Applicable Vehicles					
Model(s)	Year	Eng. Code	Trans. Code	VIN Range From	VIN Range To
Jetta	2020 - 2021	1.4T DGXA	All	All	All

Customer states there is low or no heat output from the air vents under certain cold weather conditions.

Current Engine/Motor Control Module -J623- software can cause low engine heat output or may lead to various fault codes within the vehicle.

Figure 1.

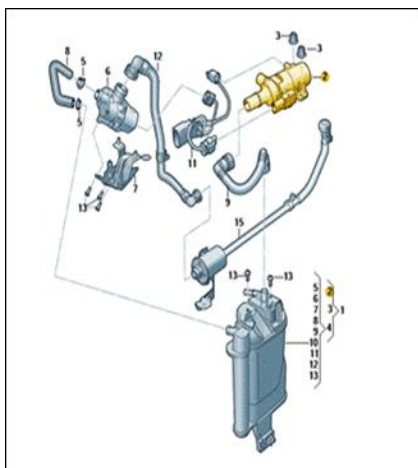
In addition to the software improvement, there is also an improvement to the FTIV (fuel tank isolation valve/tank switch-off valve -N288-) (Figure 1.), which is necessary in preventing erroneous occurrences of the P2421 fault code.

The FTIV / Tank switch-off valve -N288- currently installed on the vehicle must be inspected, to verify whether an improved part has already been installed. The FTIV / Tank switch-off valve -N288 is mounted to the EVAP canister assembly, as shown below.

Figure 2.

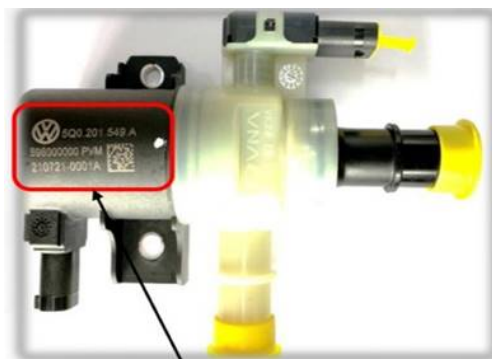
Remove the EVAP canister assembly and inspect the face of the FTIV / Tank switch-off valve -N288. If the part is already updated, it will have a white paint marking or "02S" printed after the part number, as shown in Figure 2 and Figure 3.

- If the part has a white paint mark or "02S", the FTIV / Tank switch-off valve -N288- is already the updated component. In this case DO NOT replace it, and instead reinstall the EVAP canister assembly. Only the software update will be required.
- If there is no white paint mark or "02S" are visible on the FTIV / Tank switch-off valve -N288, the component must also be replaced in addition to the software update. Always refer to ETKA for the most up to date part number information.
